M E M O R A N D U M  
\* \* \* \* \*

SUBJECT: Swisher Coal Company (G.E.X.)  
Huntington Canyon #4 Coal Mine  
Sediment Pond Design  
ACT/015/004

DATE: July 31, 1979

HYDROLOGIC REQUIREMENTS

Composite Hydrograph  
for Emergency Spillway.

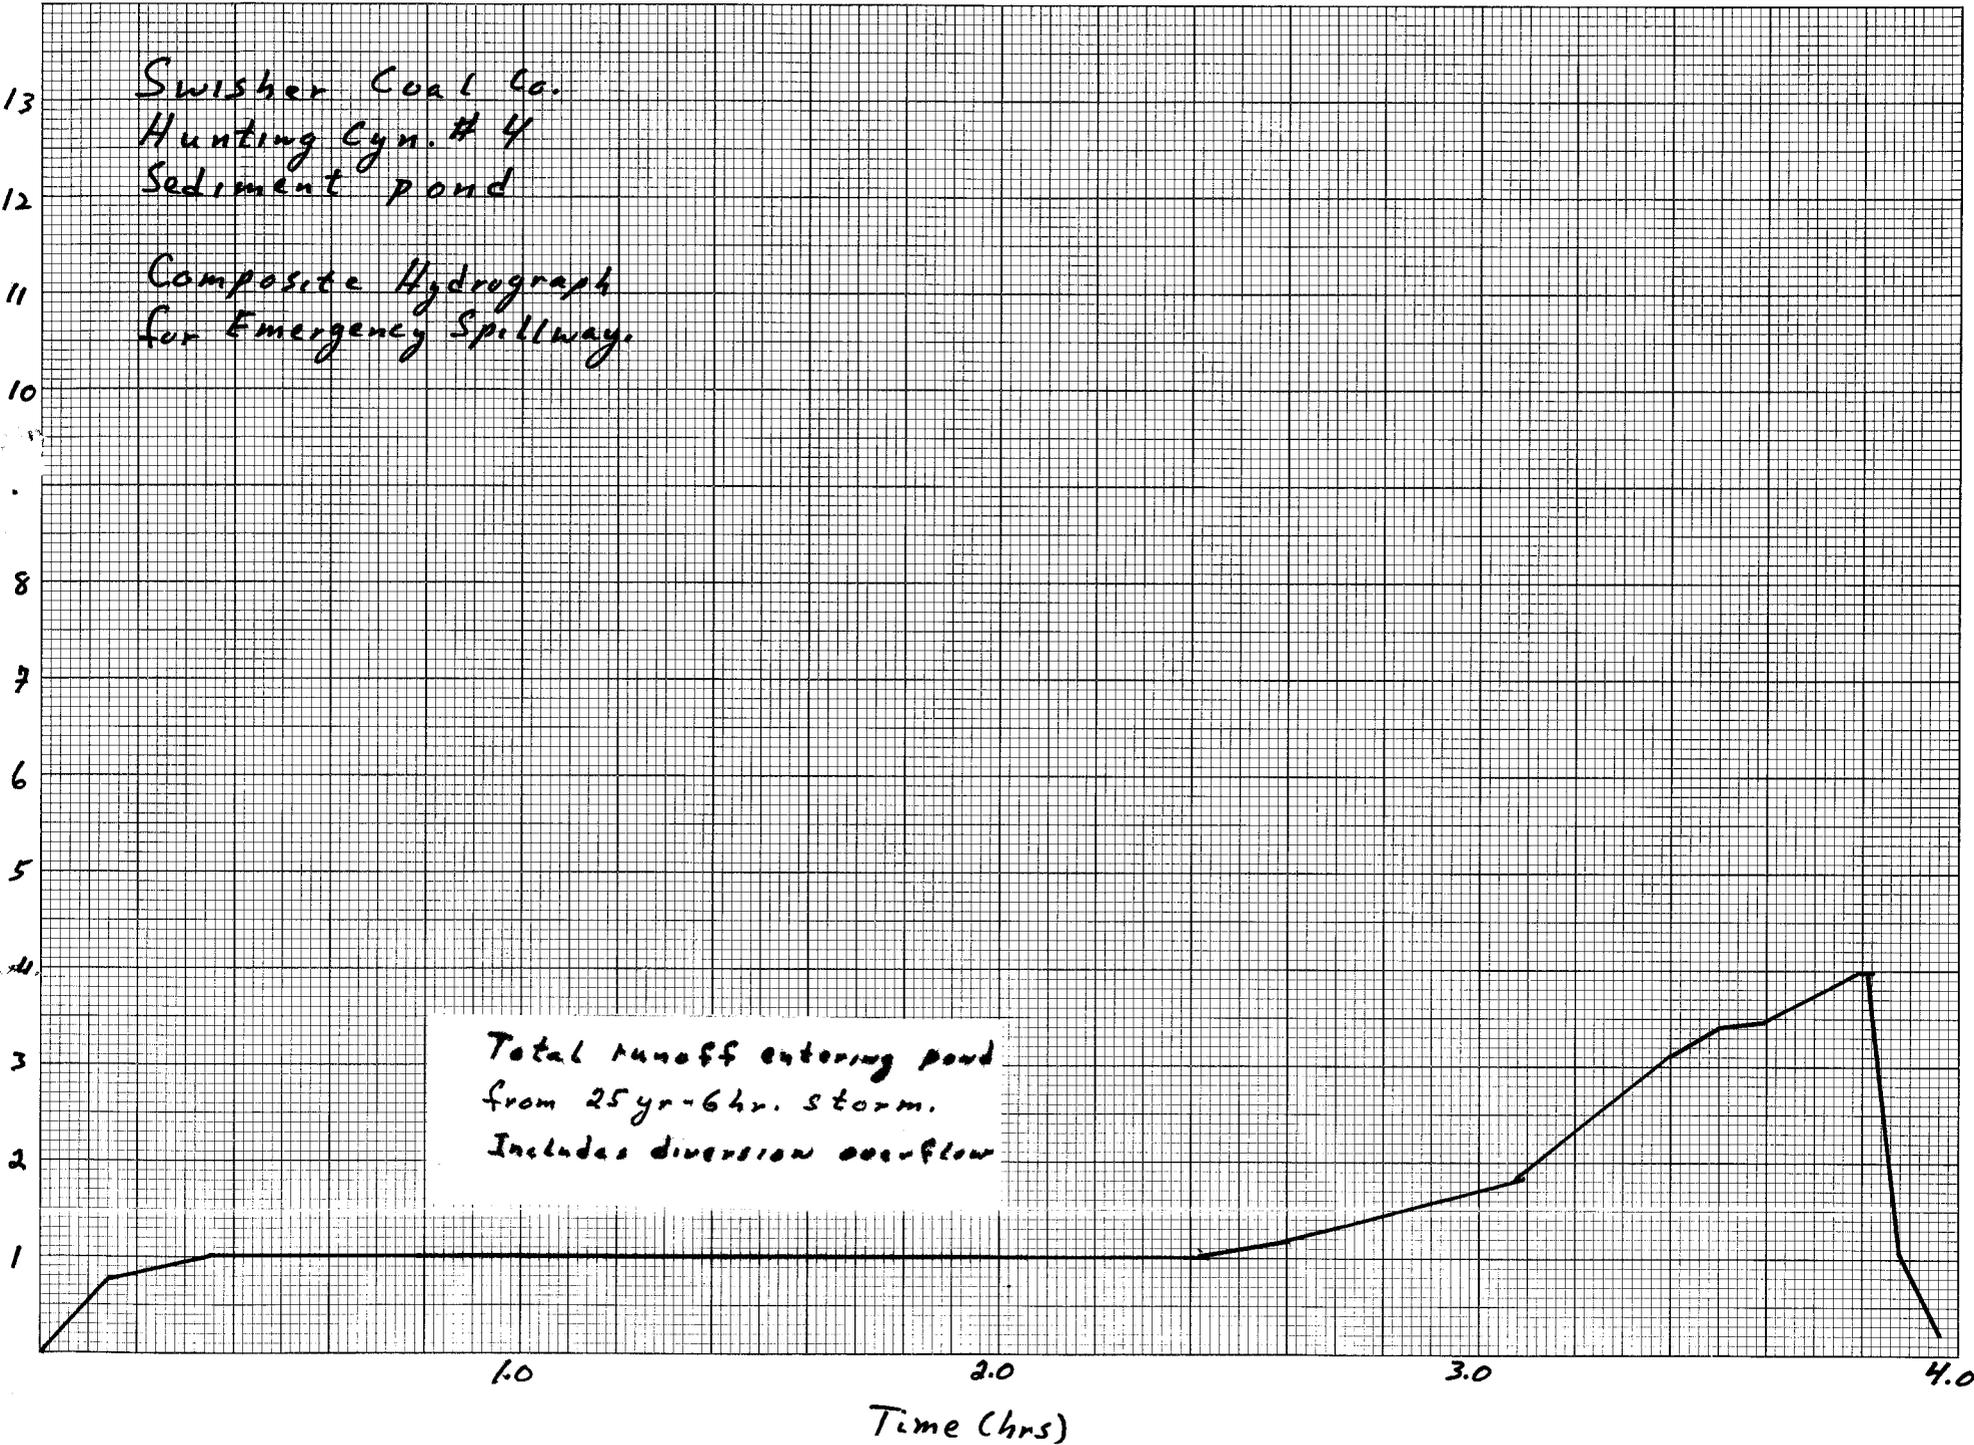
Assuming diversions are constructed to pass the peak flow resulting from the 10 year - 24 hour storm (8.4 cfs), the peak flow from within the diversion system and the diversion system overflow resulting from the 25 year - 6 hour storm is 4 cfs. Therefore the spillway should be capable of passing 4 cfs.

**Peak Flow = 2 cfs**

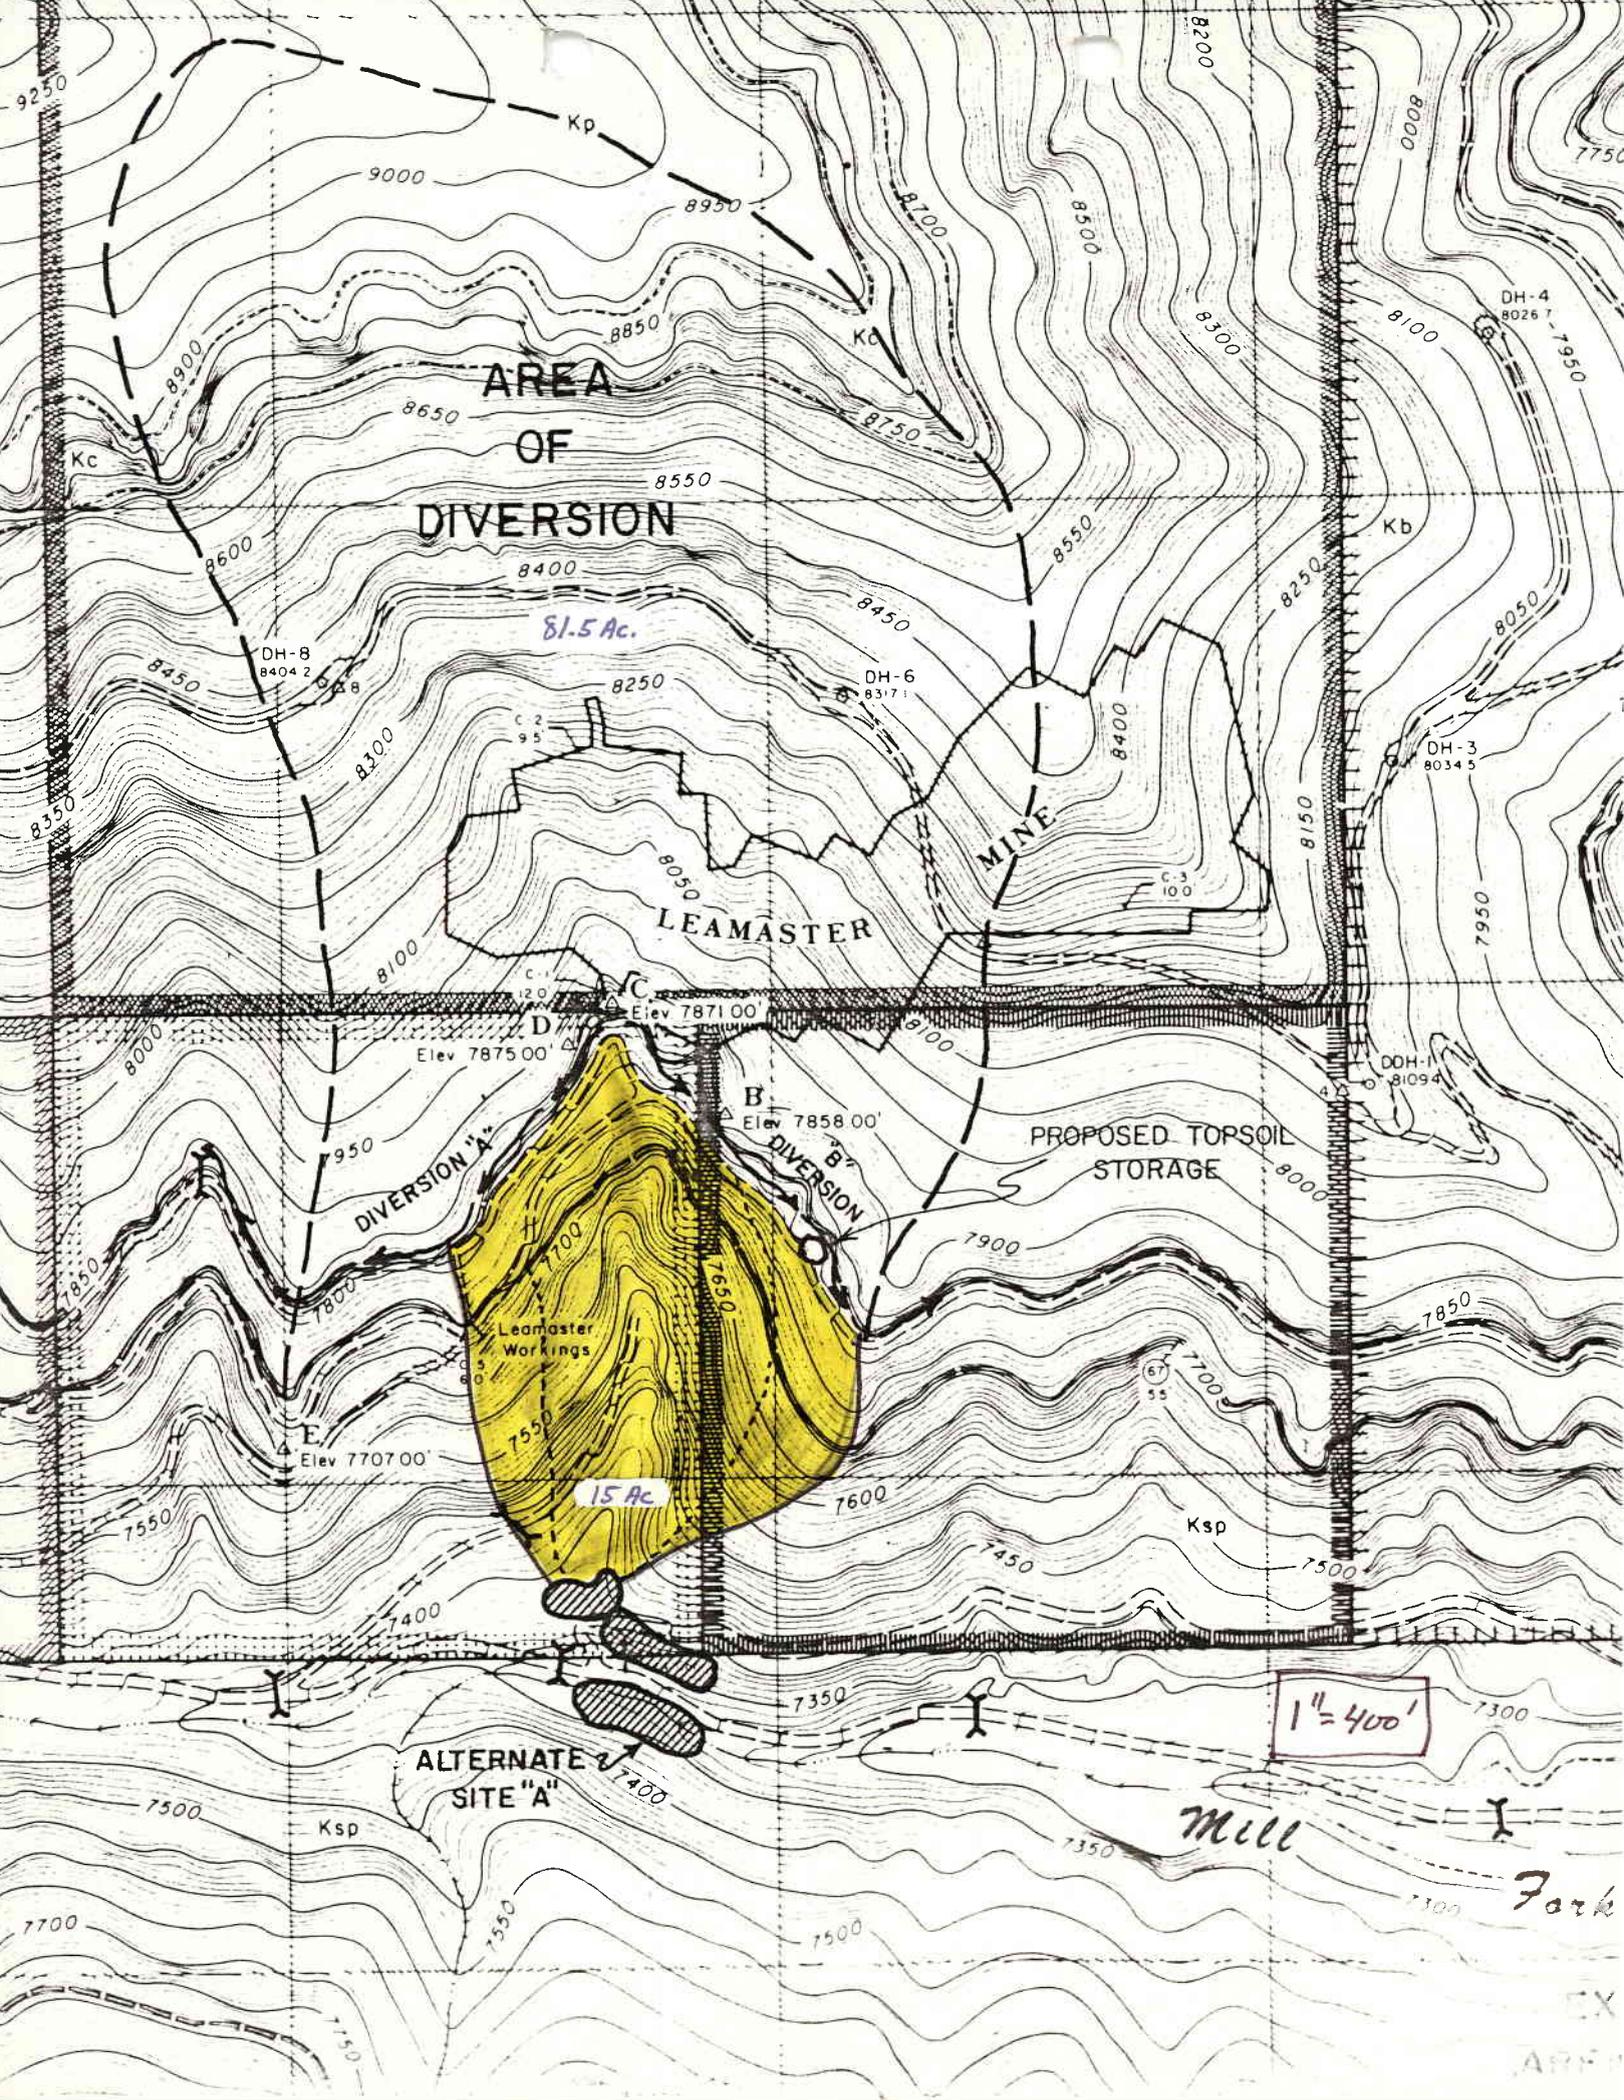
In regards to the Office of Surface Mining's stipulations concerning the sediment pond I offer the following comments. 1. The sediment pond design as proposed in Exhibit 19 is approved in item 1 of the July 6, 1979 list of stipulations. 2. A map of the scale of 1" = 400' is in the application; a copy is in the enclosed hydrologic study. 3. Of most importance, I would like to point out that the State has determined that diversion structures should be designed and constructed between the highwall, composed of bedrock, and the surface facility pad. Construction of diversions above the highwall is dangerous to workers and existing facilities, will create more disturbance and will probably function no better than the diversion proposed. I also feel that we can obtain written concurrence from the U.S. Forest Service, the land management agency.
